ADDENDUM

NO. 1

PROJECT NAME: New Operations Building

PROJECT NUMBER: 1971-05-01

PACKAGE	VOLUME
Job No. 1971-05-01	Sheet No. M1.02
Drawn By: DB	
Date: 09/16/2025

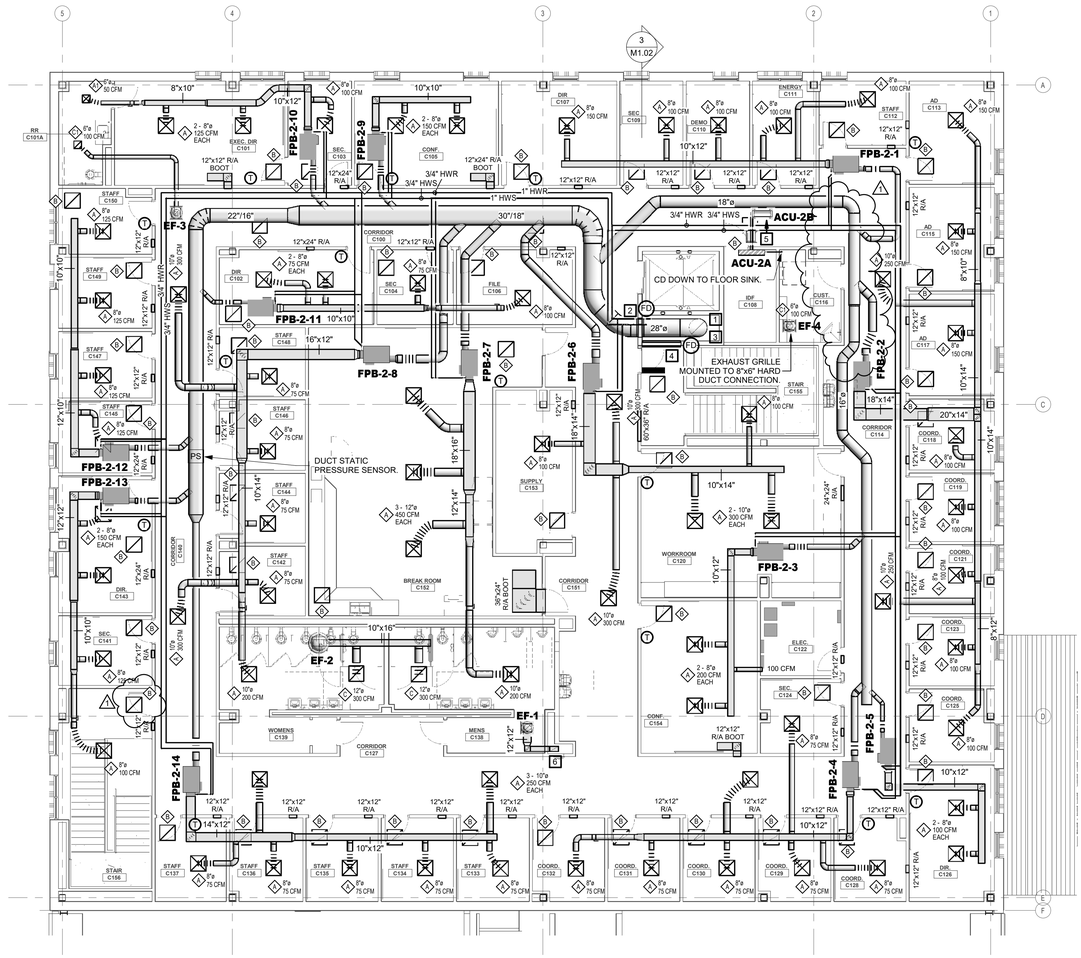
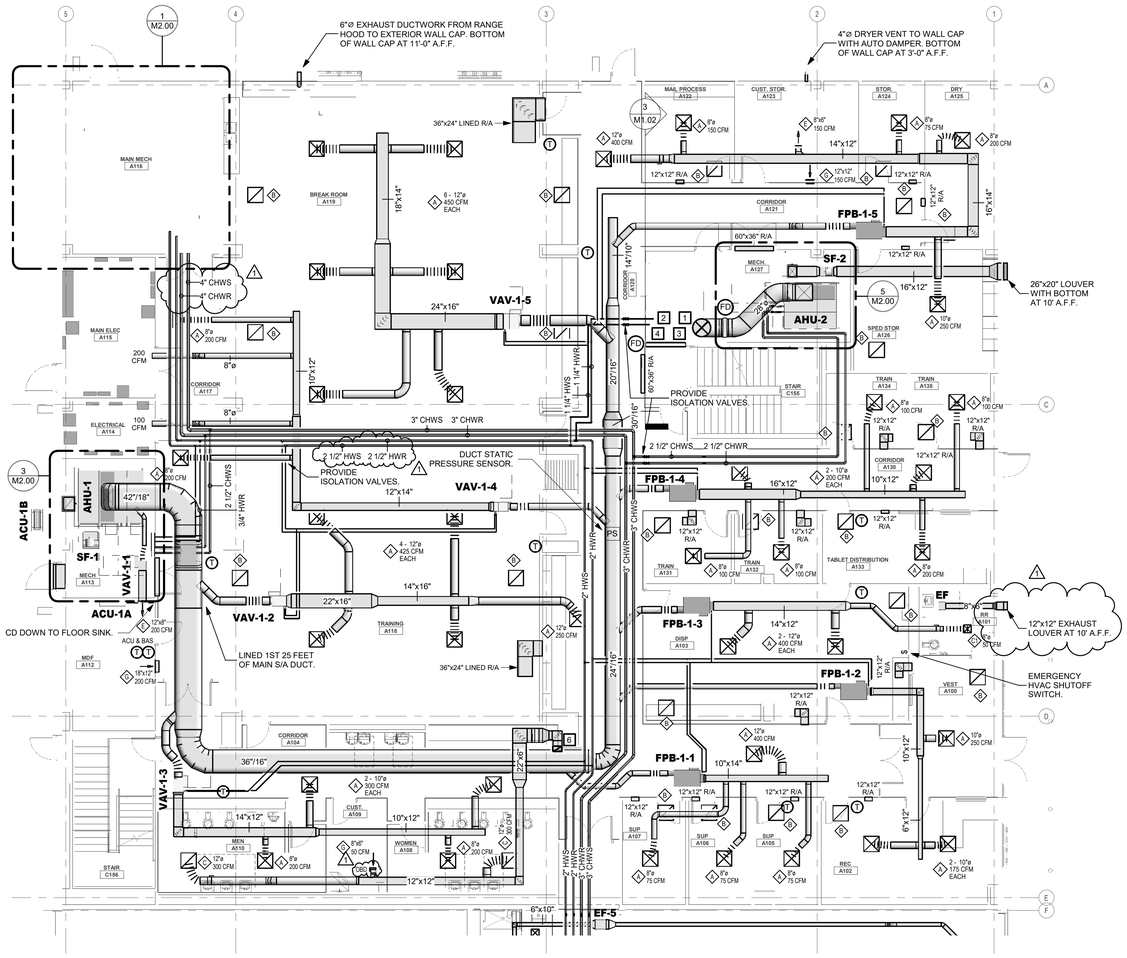
AD No 1, Mech. Item 7: To the Drawings, Sheet M1.02, "MECHANICAL FLOOR PLAN – LEVEL 1/2 AREA A/C – OPERATIONS BUILDING,"

1 MECHANICAL CENTRAL PLANT DETAIL PLAN
SCALE= 1/4" = 1'-0"

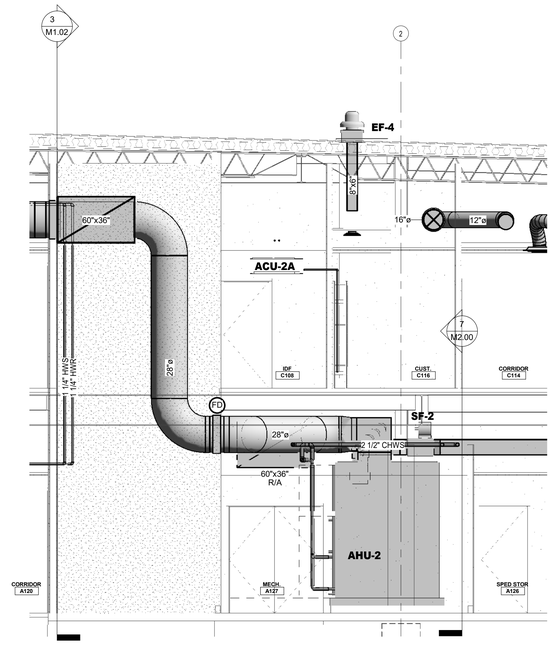
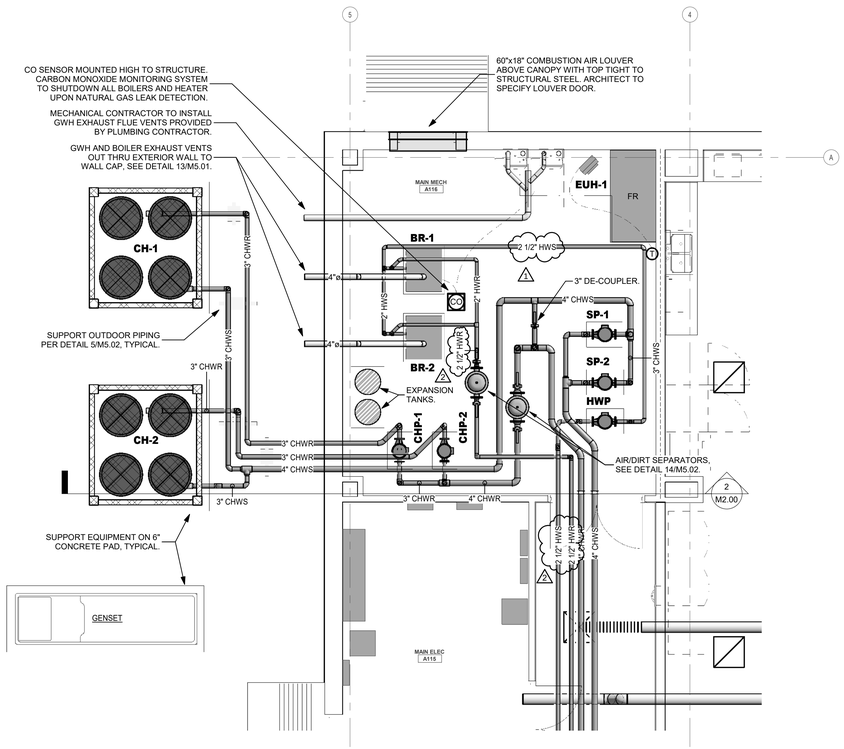
AD No 1, Mech. Item 9: To the Drawings, Sheet M2.00, "MECHANICAL DETAIL PLANS AND SECTIONS,"

1) Detail 1 – MECHANICAL CENTRAL PLANT DETAIL PLAN: Revise hot water piping size as indicated.
2) Detail 7 – AHU-2 SECTION #2: Revise the outside air duct termination height as indicated.

PACKAGE	VOLUME
Job No. 1971-05-01	Sheet No. M6.01
Drawn By: Author	
Date: 09/18/2025

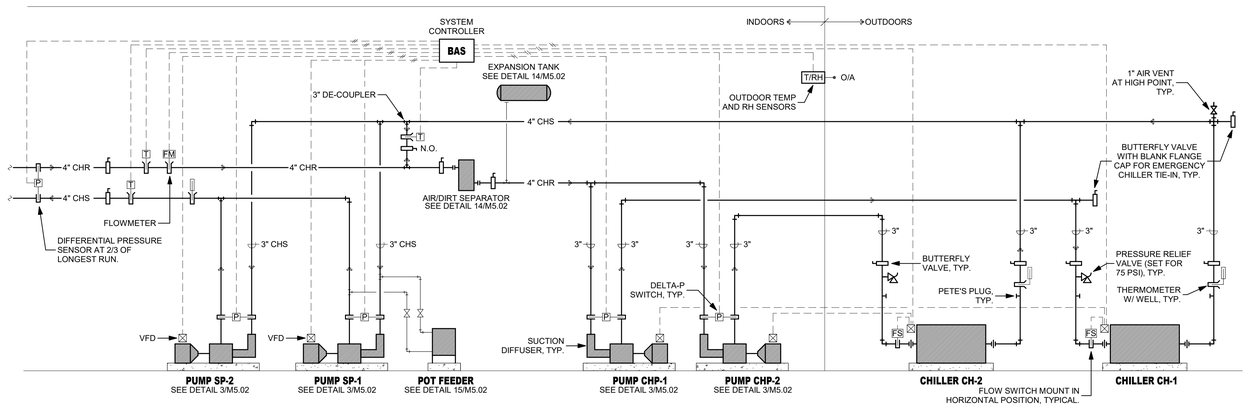
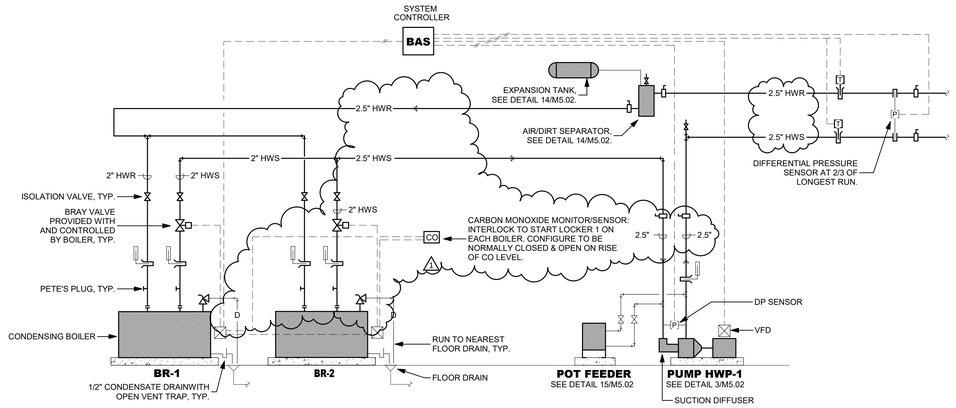
AD No 1, Mech. Item 12: To the Drawings, Sheet M6.01, "MECHANICAL SCHEMATICS,"

1 ELECTRICAL SITE PLAN

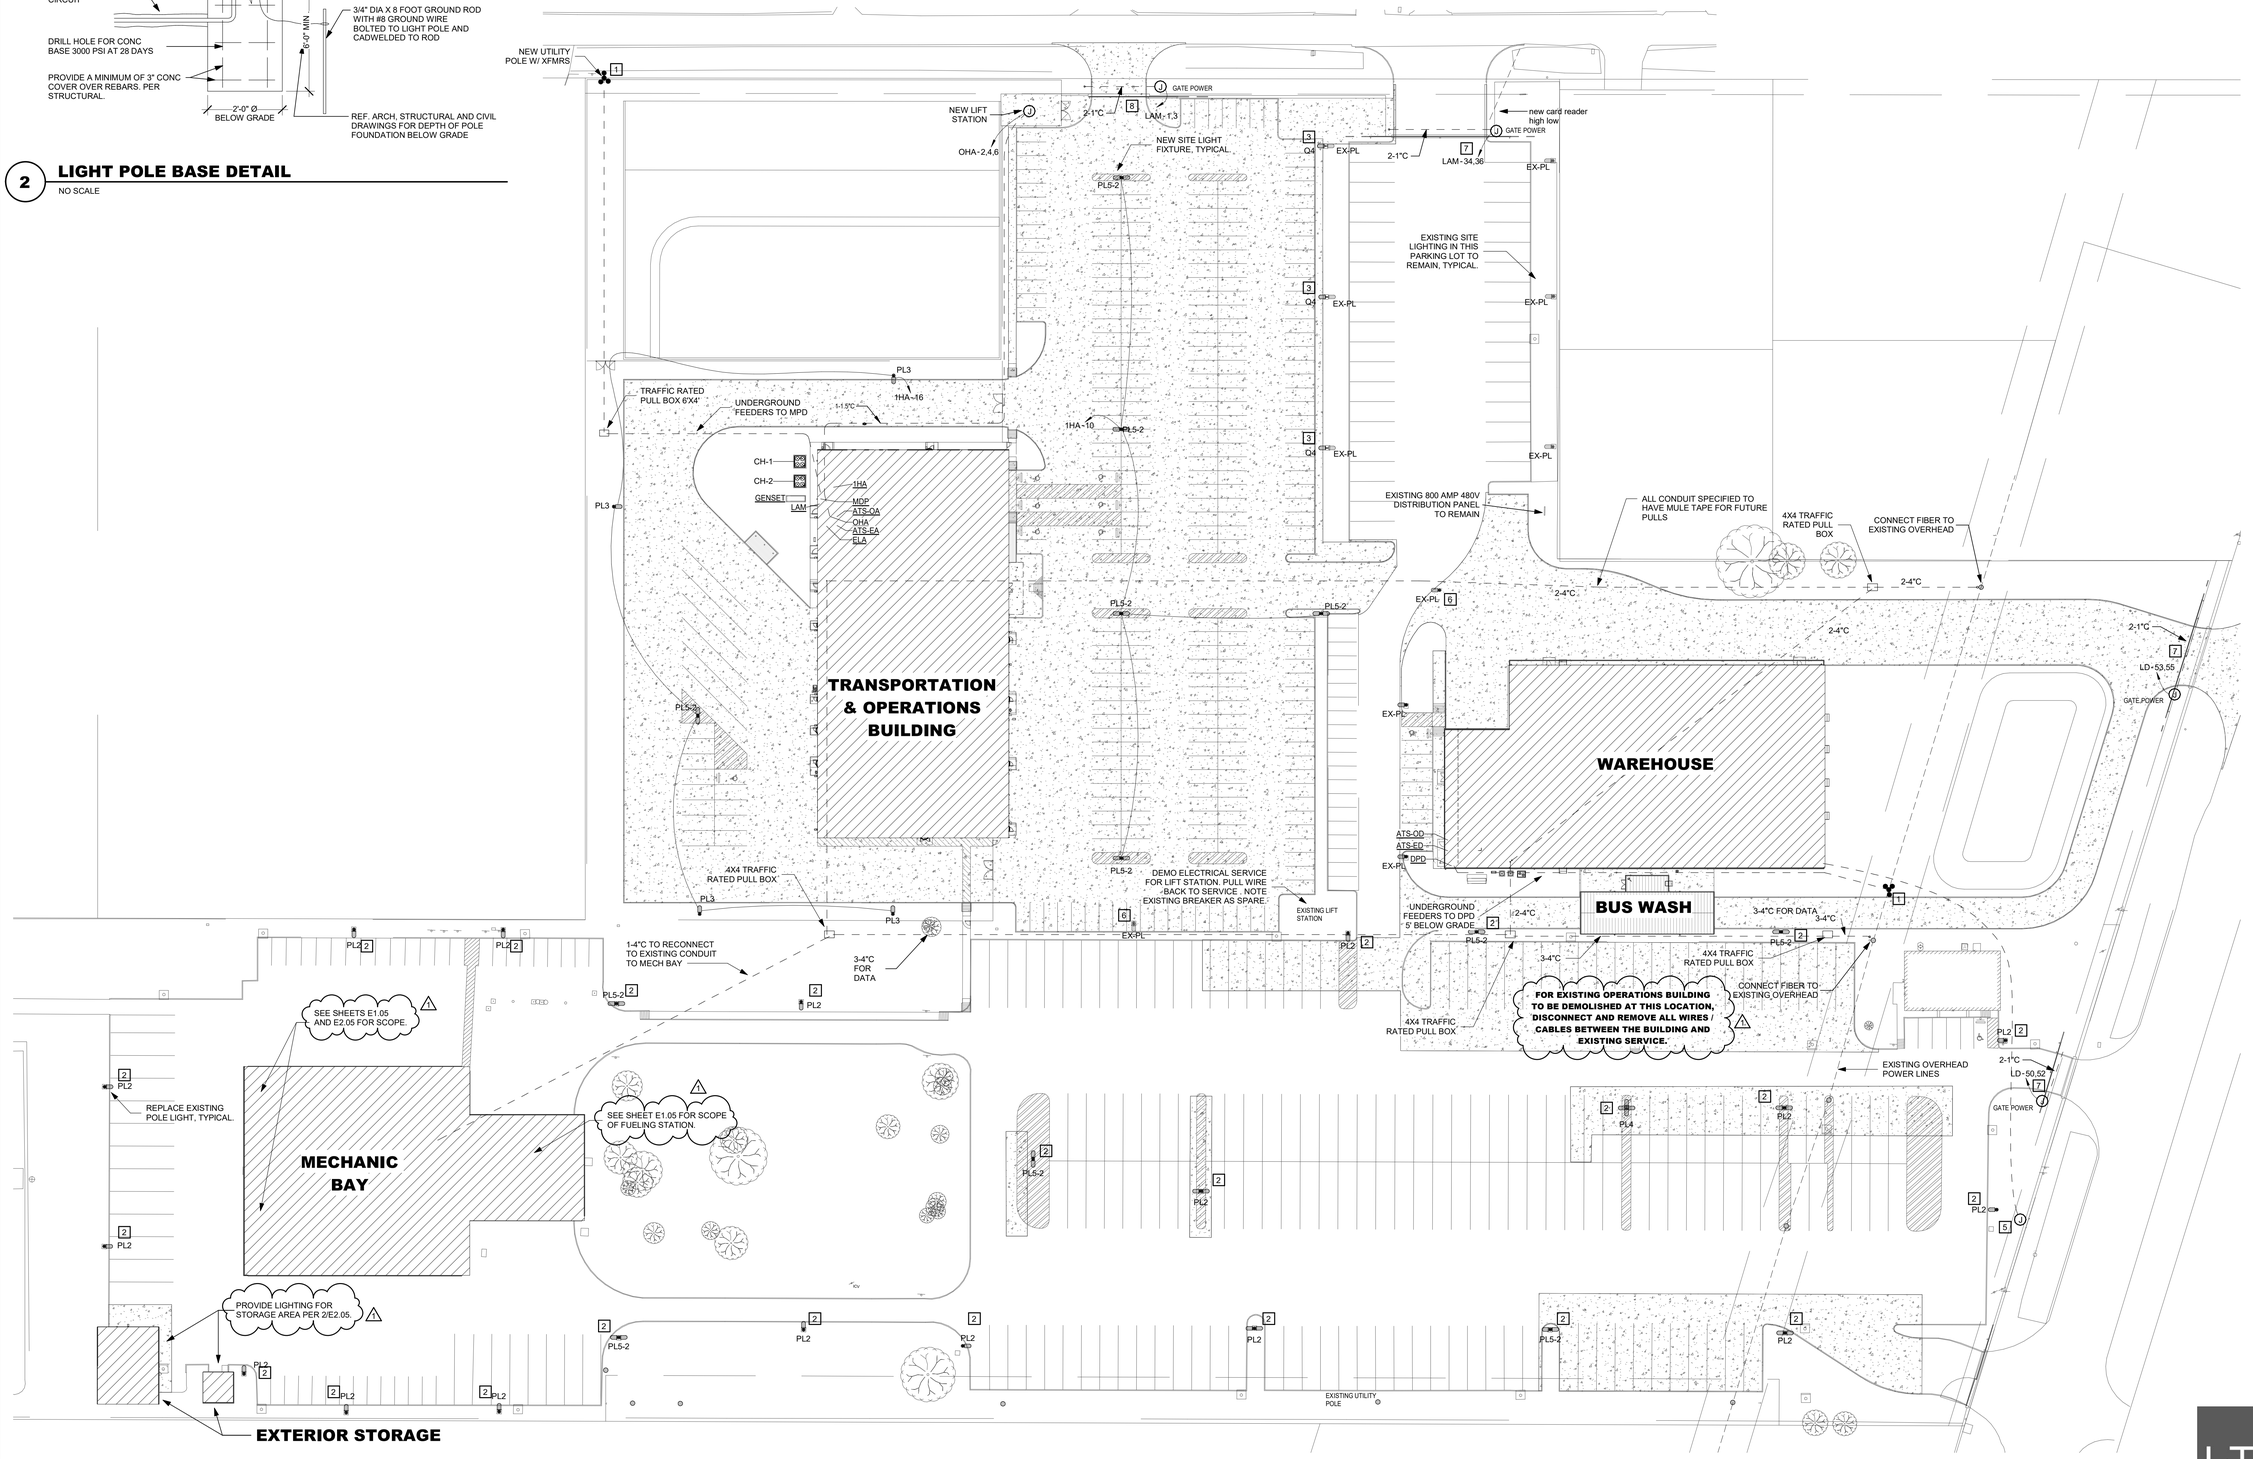
AD No 1, Elec. Item 7: To the Drawings, Sheet E1.00, "ELECTRICAL SITE PLAN
1) Clarified scope for buildings/areas.
2) Clarified demo scope for existing building.

PACKAGE	VOLUME
Job No. 1971-05-01	Sheet No. E1.02
Drawn By: HB/BRH	
Date: 09/18/2025

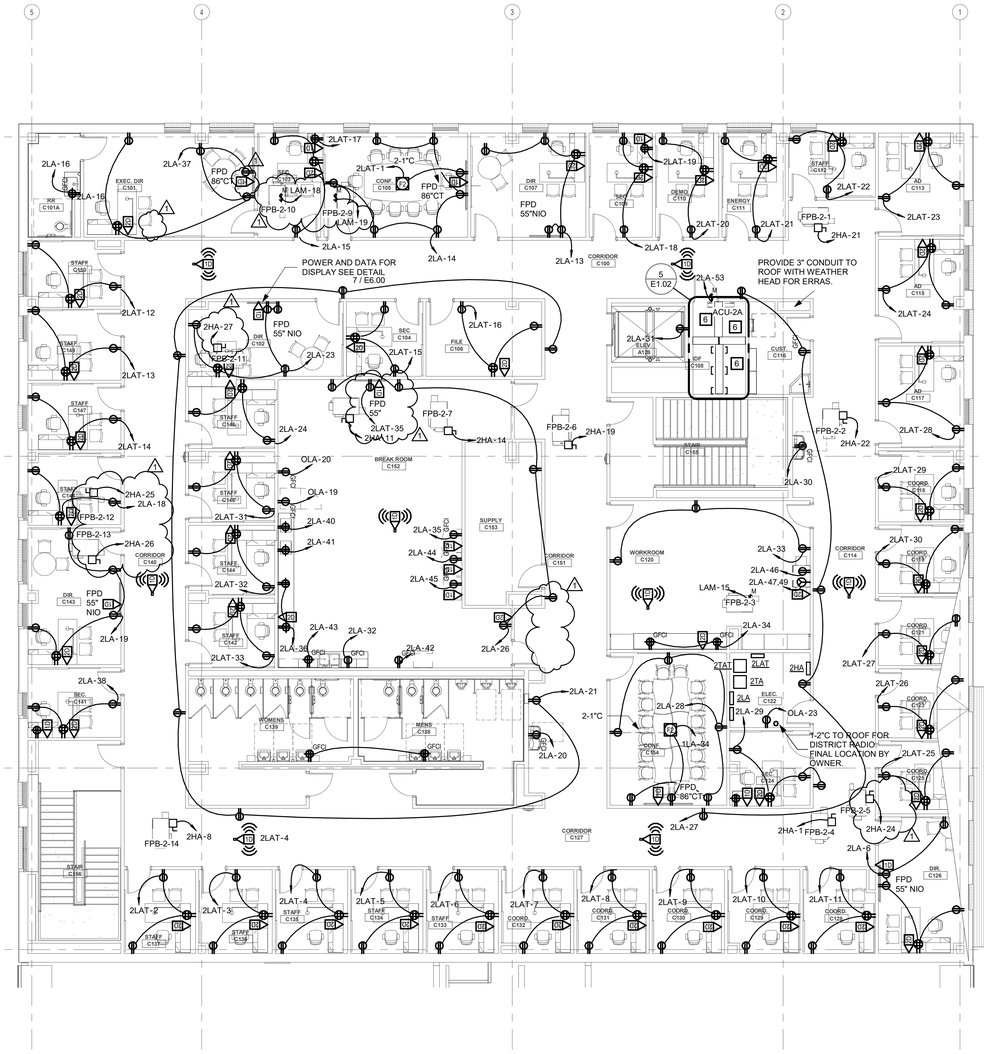
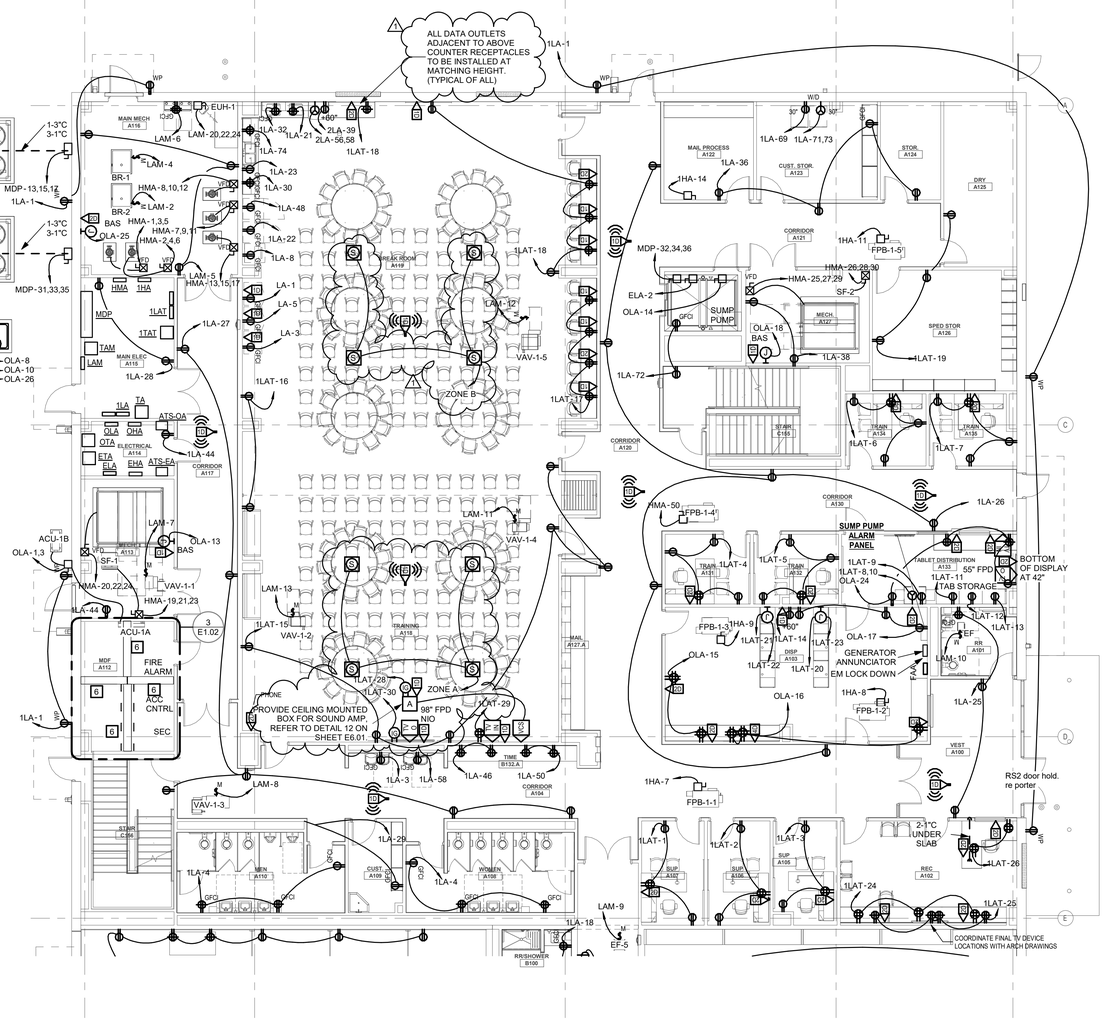
AD No 1, Elec. Item 8: To the Drawings, Sheet E1.02, "POWER FLOOR PLAN – LEVEL 1 / 2 – AREA A / C"
1) Revised various FPB units from 120 volt to 277 volt. Refer to drawings for locations.
2) Provided dedicated circuit in C152 break room for FPD.
3) Moved data drop to adjacent wall for FPD in C101.
4) Shifted receptacle in corridor C151.
5) Revised power circuits for general purpose receptacles in MDF.
6) Added note in break room to coordinate data drop height for all data drops adjacent to above counter receptacles.

PACKAGE	VOLUME
Job No. 1971-05-01	Sheet No. E1.03
Drawn By: HB/BRH	
Date: 09/18/2025

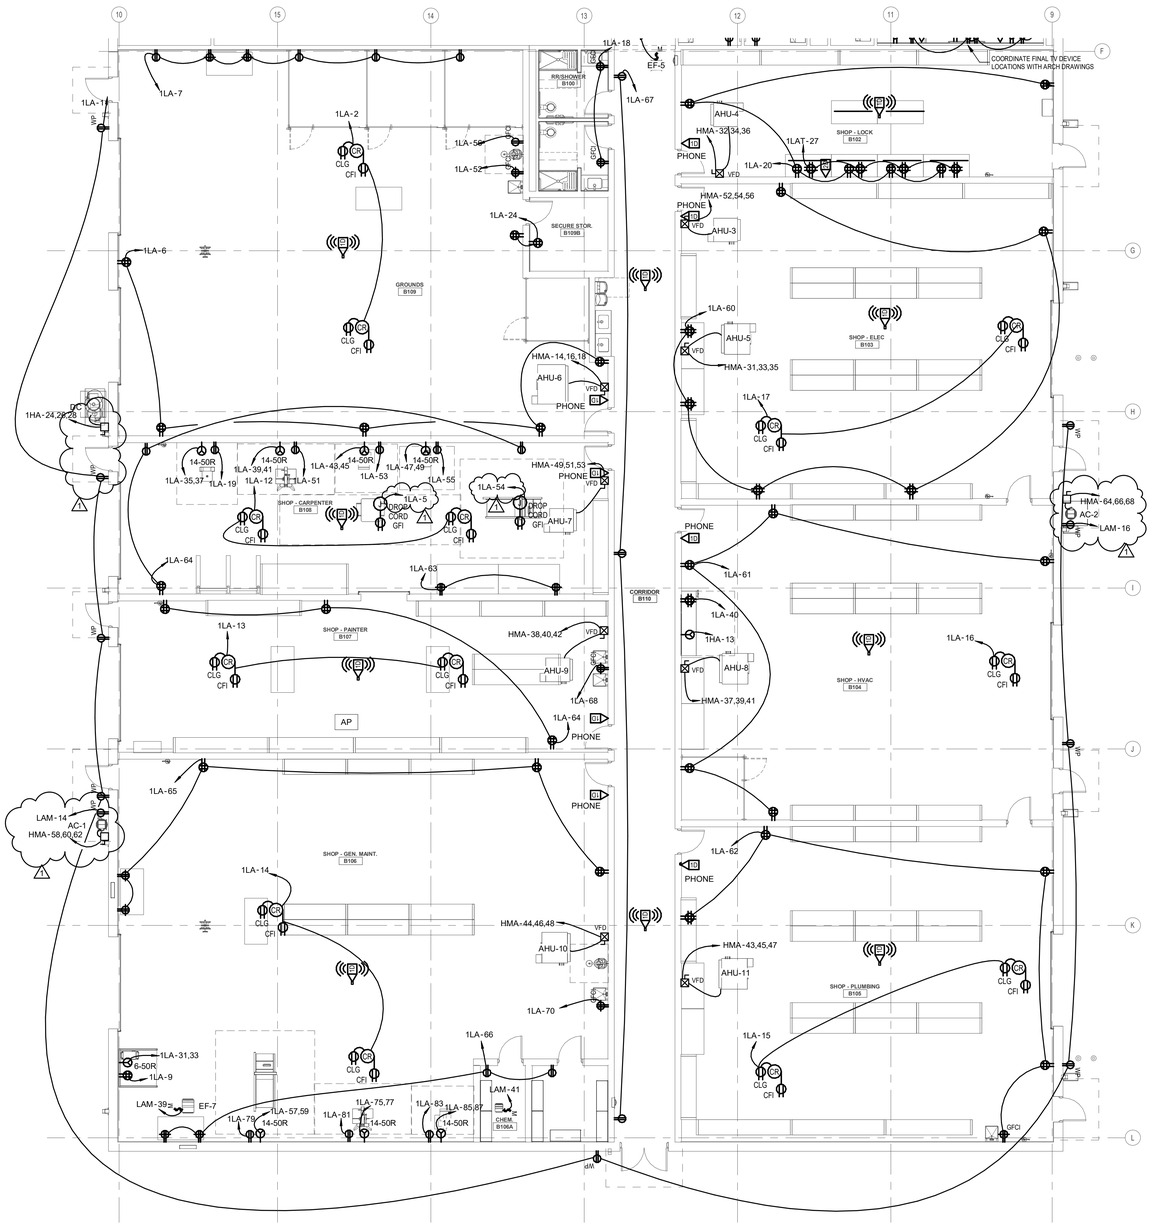
AD No 1, Elec. Item 9: To the Drawings, Sheet E1.03, "POWER FLOOR PLAN – LEVEL 1 – AREA B – OPERATIONS BUILDING"
